Ref: P210203/so'r

RE: EQUINIX (IRELAND) LTD.,
PLOT 100, PROFILE PARK, NANGOR ROAD, CLONDALKIN, DUBLIN 22,
PLANNING REG. REF. SD21A/0186

Please find our response to Item No.'s 4 & 6, addressing the Request For Additional Information pertaining to the above project, as dated 30th August 2021, together with 6 No. copies of all documentation, as mentioned below:-

SITE:	EQUINIX - PROFILE PARK, LUCAN, TANK 3 95m3	JN210609		1	28/07/21
		DRAWING NO.		PAGE NO.	DATE.
TITLE:	PLAN	NTS	LP	LP	A
		SCALE	DRAWN.	CHECKED.	REVISION.

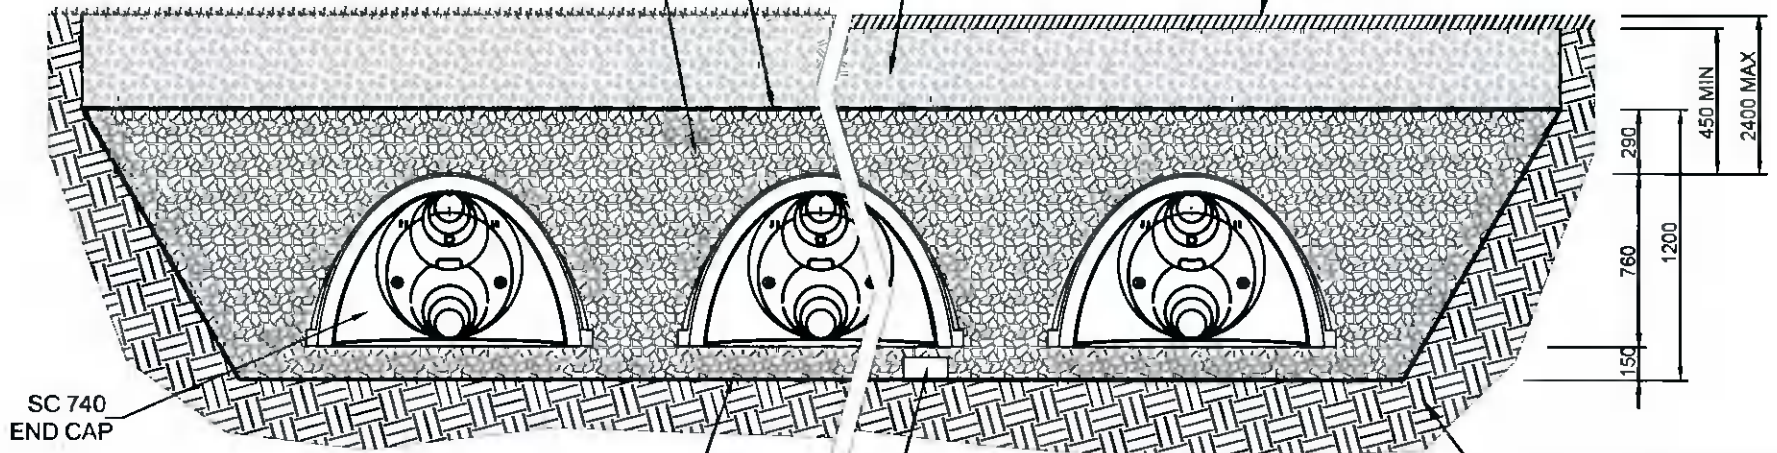
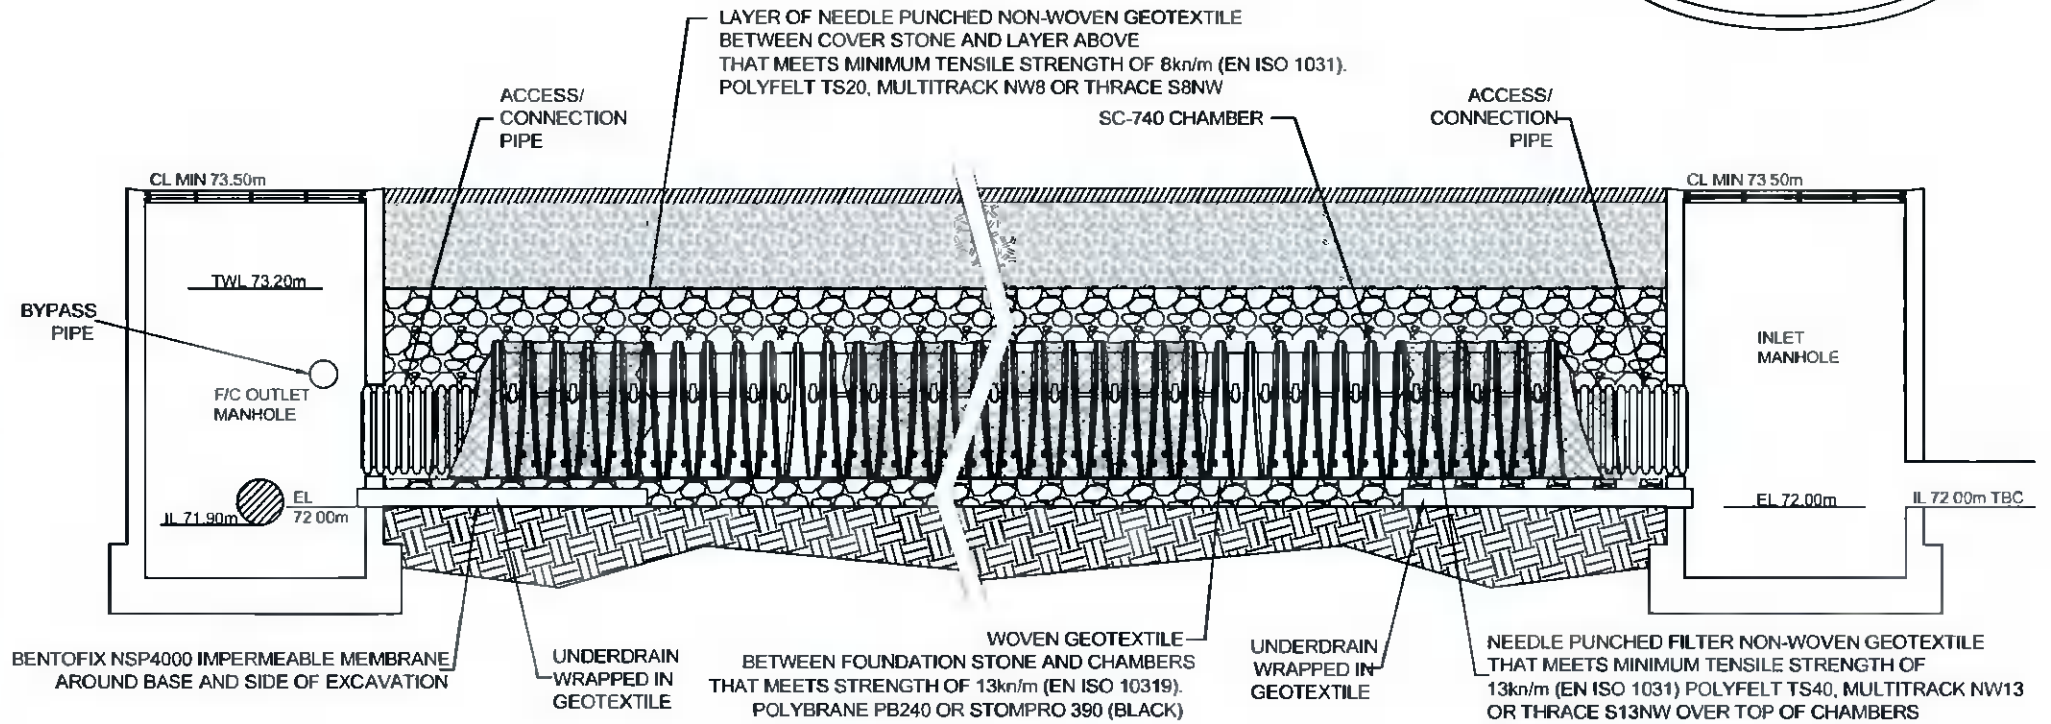
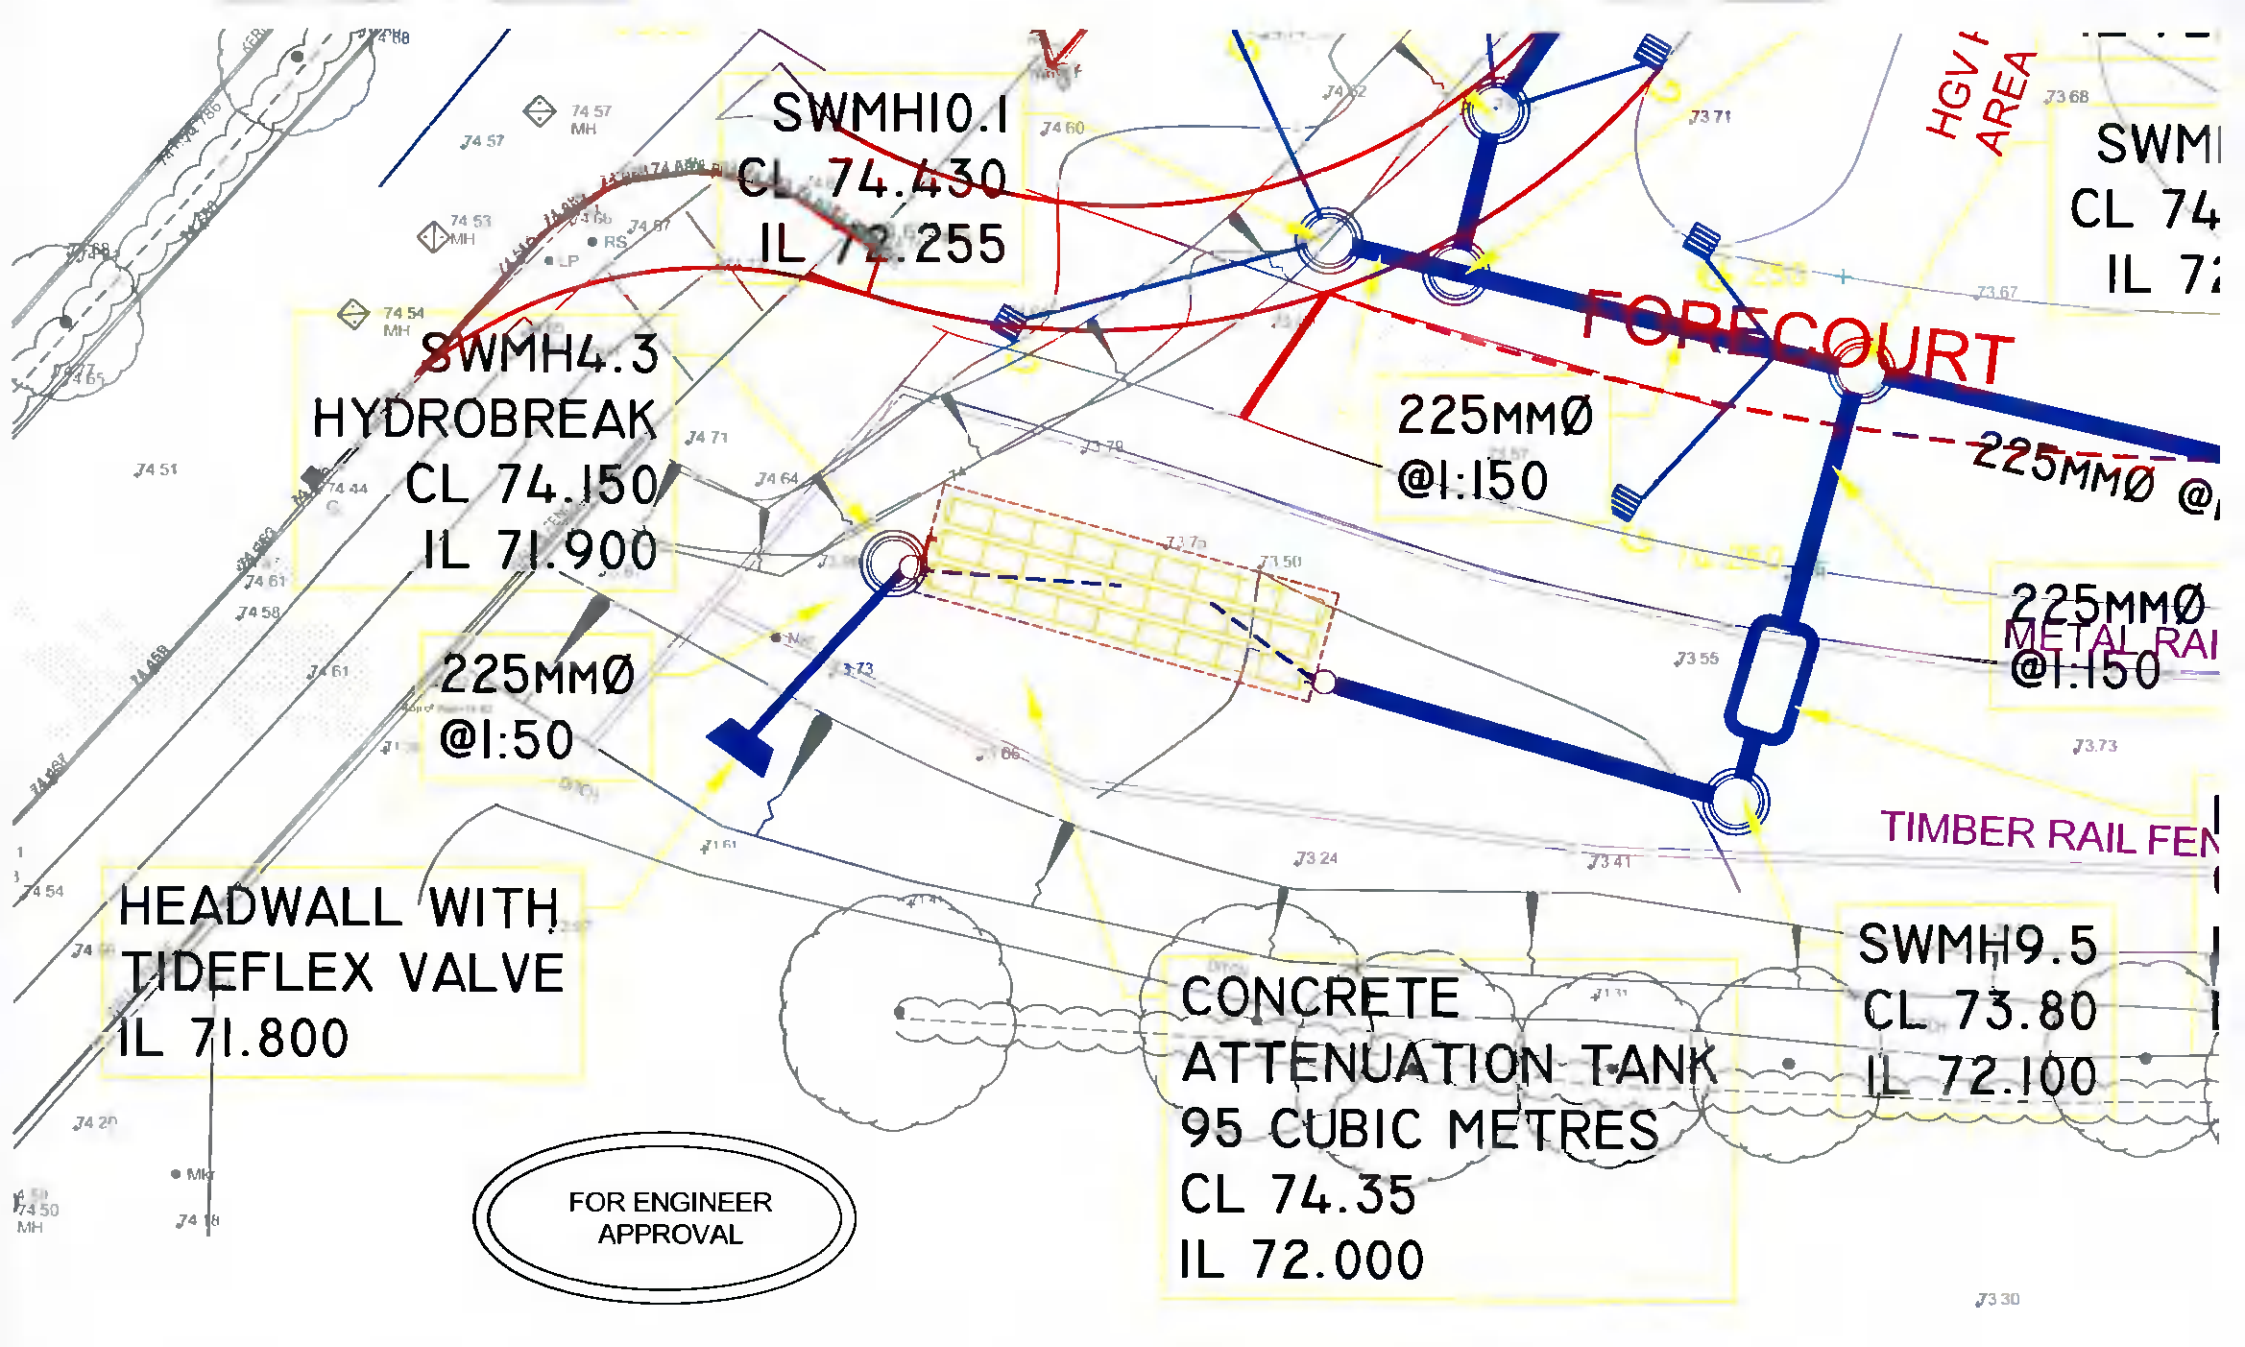
(c) The applicant is requested to minimise the use of underground attenuation systems on site. Where this cannot be achieved arch type systems should be installed as oppose to concrete tanks. The applicant is requested to submit a cross section detail of the proposed attenuation pond and underground attenuation systems.

Attenuation Tank 1 and Attenuation Tank 3 will be a Stormtech attenuation tanks, please see details attached in Annexure F.
